**APPLICATION FOR RESOURCE CONSENT RMA/2023/597
ADDRESS 130 BOWENVALE AVENUE**

Thank you for your application for resource consent for 35 lot fee simple subdivision on the above site, which we received on 11th April 2023.

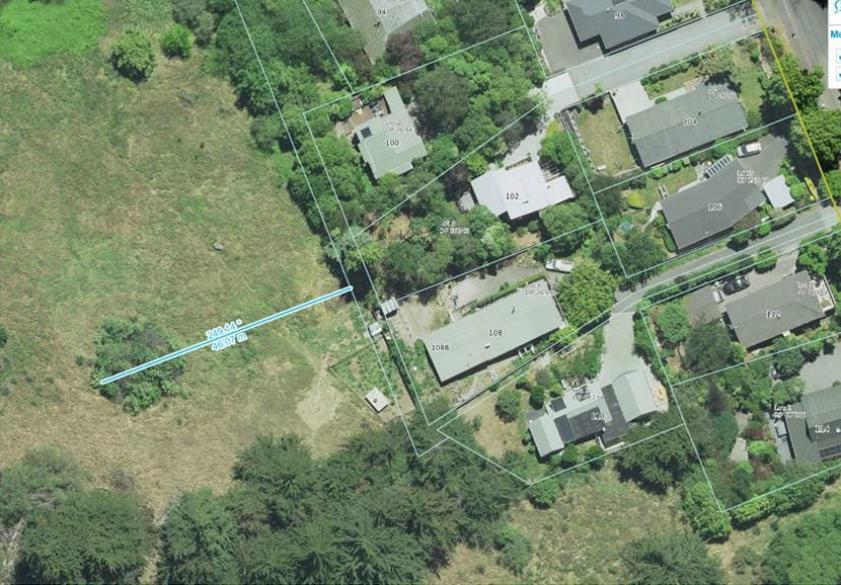
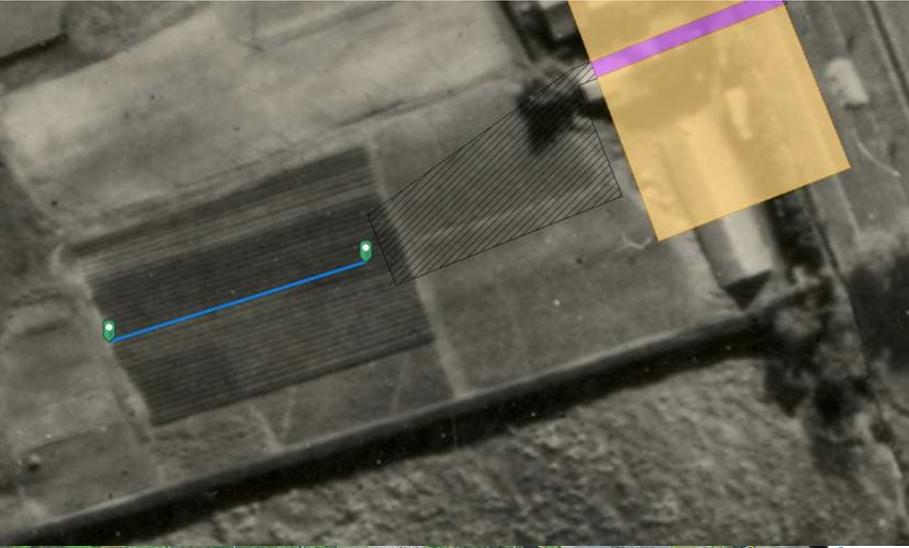
32. Aerial photos from 1945-1949 have been reviewed as part of the environmental health officers assessment. It appears that part of a market garden is located within the application site. Please can a suitably qualified and experienced practitioner further investigate this area?

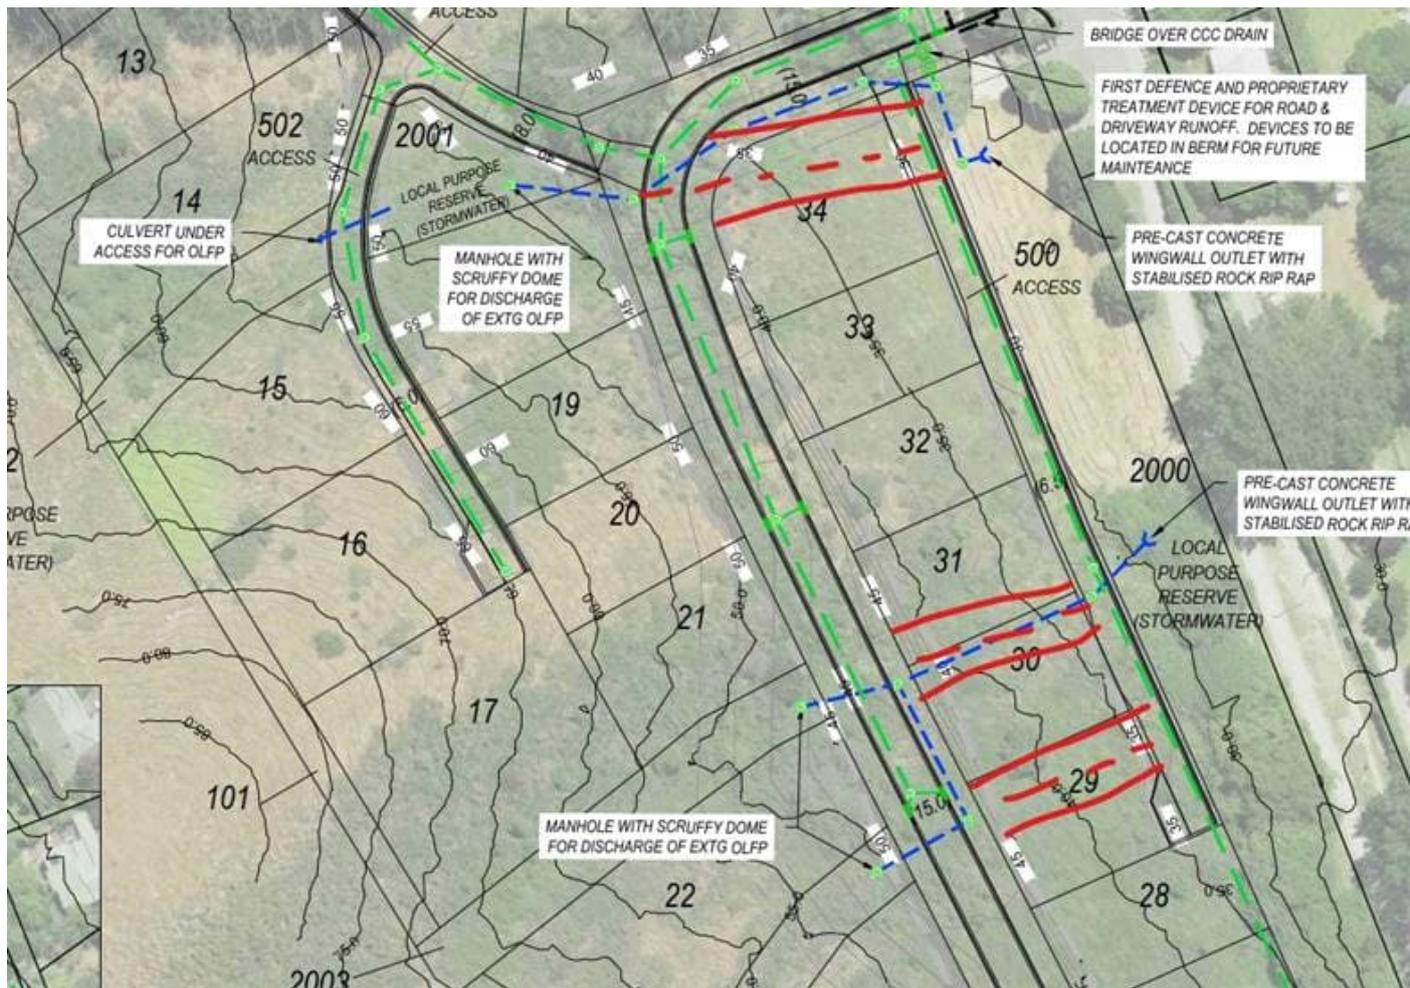
- The current setback proposed from of the Hill waterway is not accepted by the specialists. It would be optimal for the compliant setback to apply (20m total area measured from the centreline of the waterway to 10m out on both sides), however a further discussion is recommended on this matter;

- The piping of the hill waterway from the proposed road within the development site is not supported due to the steepness and terrain of the area;
- While the planting palette proposed is acceptable, a 2m riparian buffer is not an adequate outcome it is recommended that a 4m wide planting buffer is proposed for the Hill waterways. This is due to the increase of impervious surfaces occurring through the proposed development. Although the tributaries of Sibleys Drain (excluding Sibley's drain) are ephemeral, native plantings within the setback can reduce soil erosion, reduce downstream flood risk through hydrological buffering, and create ecological corridors (per Policy 6.6.2.1.2 a. i). In addition, Policy 6.6.2.1.2 a. vi. b. recognises that Hill waterway setbacks have the function of maintaining or enhancing habitat for terrestrial and aquatic animals and plants.
